**MINUTES  
BOARD OF BUILDING STANDARDS/  
ARCHITECTURAL BOARD OF REVIEW/SIGN REVIEW  
REVIEW MEETING  
CITY OF LAKEWOOD  
12650 DETROIT AVENUE  
AUDITORIUM  
JULY 11, 2024  
5:30 P.M.**

**4. Docket No. 07-64-24**

5. Docket No. 06-57-24

6. Docket No. 03-13-24

**SITE PLAN**

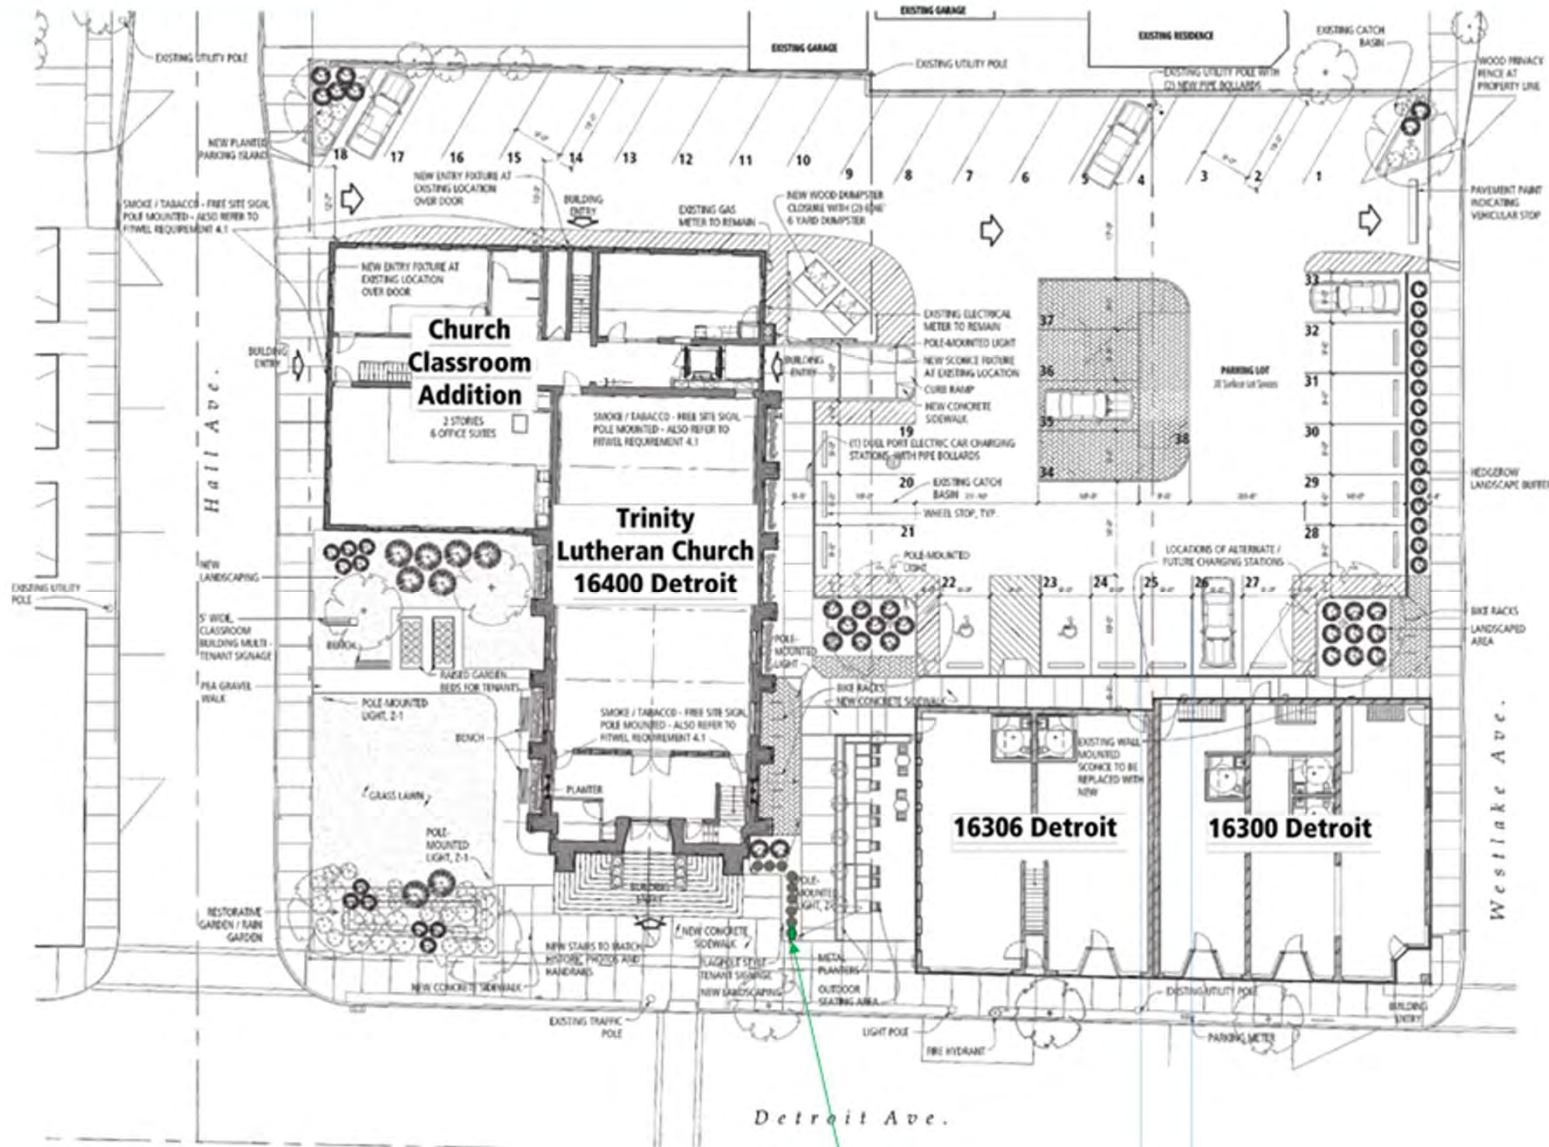
- No Comment
- **Docket 07-63-24 Body Fit Training.**
  - Per the site plan, the proposed 13' tall internally illuminated sign appears to be adjacent to a Pole Mounted Light (Fixture Z-1) and a flagpole style tenant signage. Will these other elements remain? If so, we suggest the ARB review their juxtaposition.

A motion was made by Mr. Maniet, seconded by Mr. Slaughterbeck to **APPROVE the request with the following conditions:**

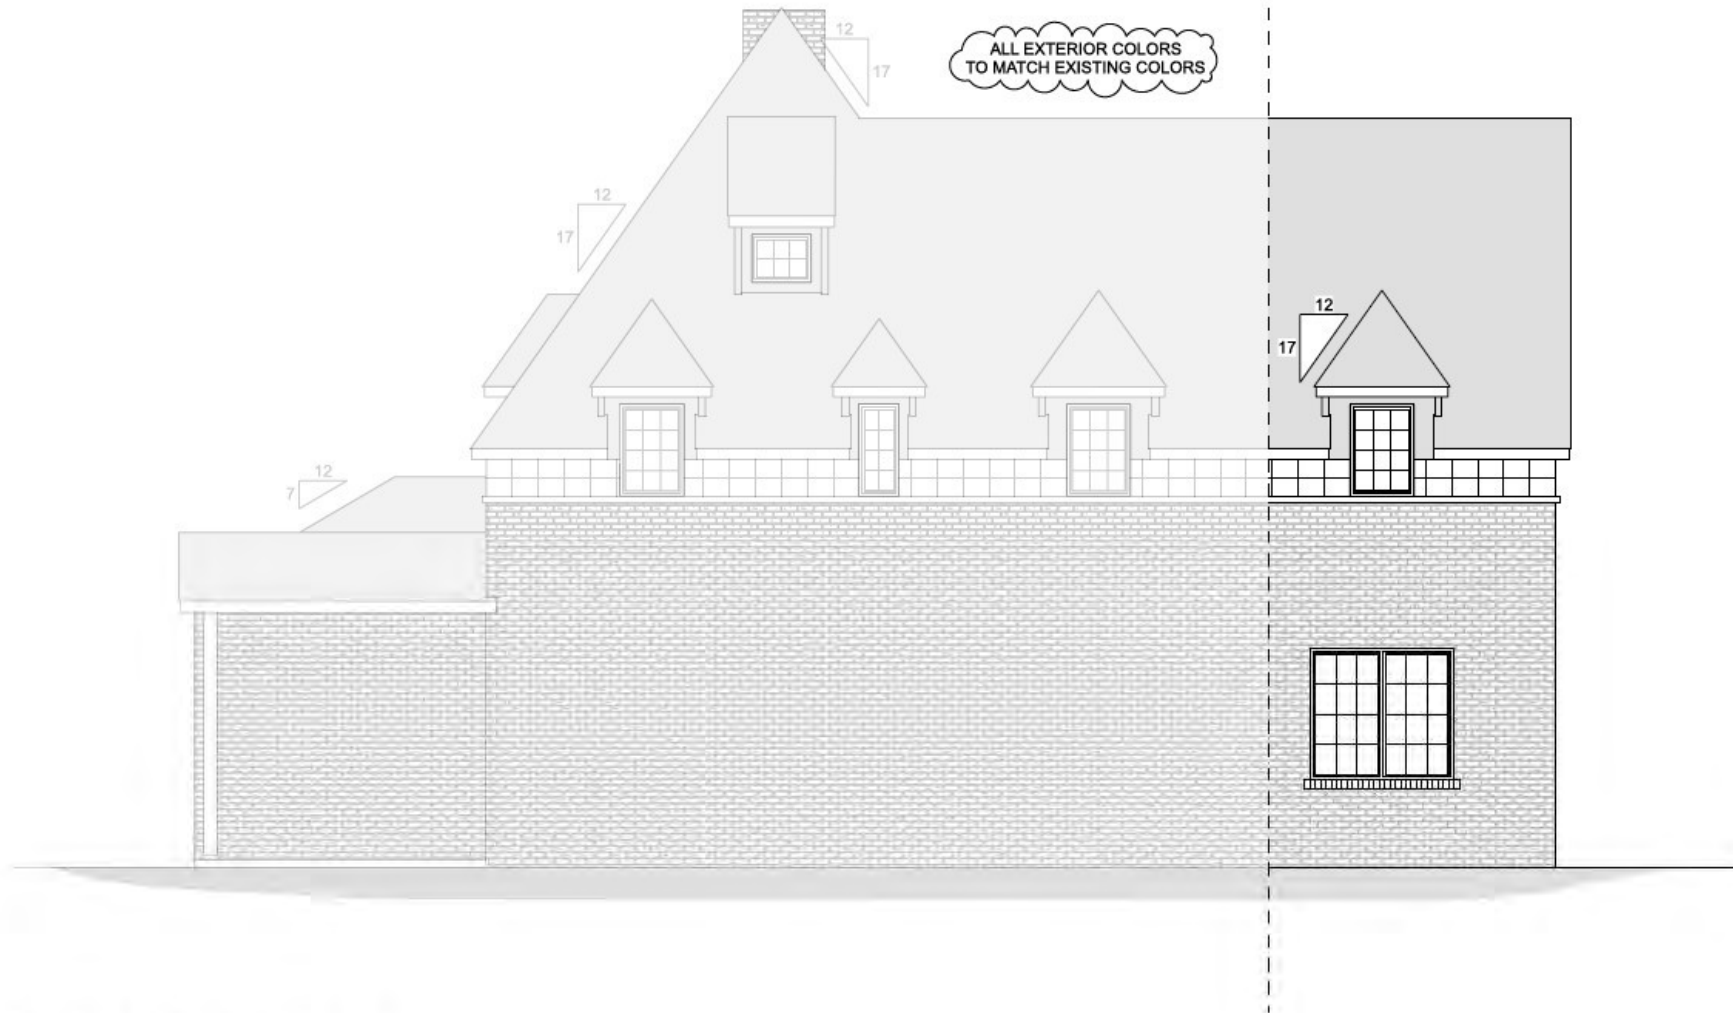
Tom Pernsteiner, property owner, and Jason Amato, 1121 Wilbert Rd. were present to explain the request. Discussion began with color of the infill banding, the need of a zoning variance, height of the second floor window, and materials. Public comment was closed as no one addressed the item. Staff did not receive comments prior to the meeting. It was suggested to extend the brick above the detailed band.

- No Comment assuming the side yard setbacks comply with the city ordinance.
- **Docket 07-68-24 1115 Wilbert Rd.**
  - It appears the proposed addition is with the front yard setback by 3.16 feet. We suggest the ARB review the front of the house with respect to the adjacent property owner to the north to ensure this variance would not affect the neighbor.

- **The second floor west facing window will be raised so the sill will be in line with all the other second floor sill heights.**
- **As an alternate use brick all the way to the peak in lieu of stucco, the brick to match the existing above the detailed white band.**
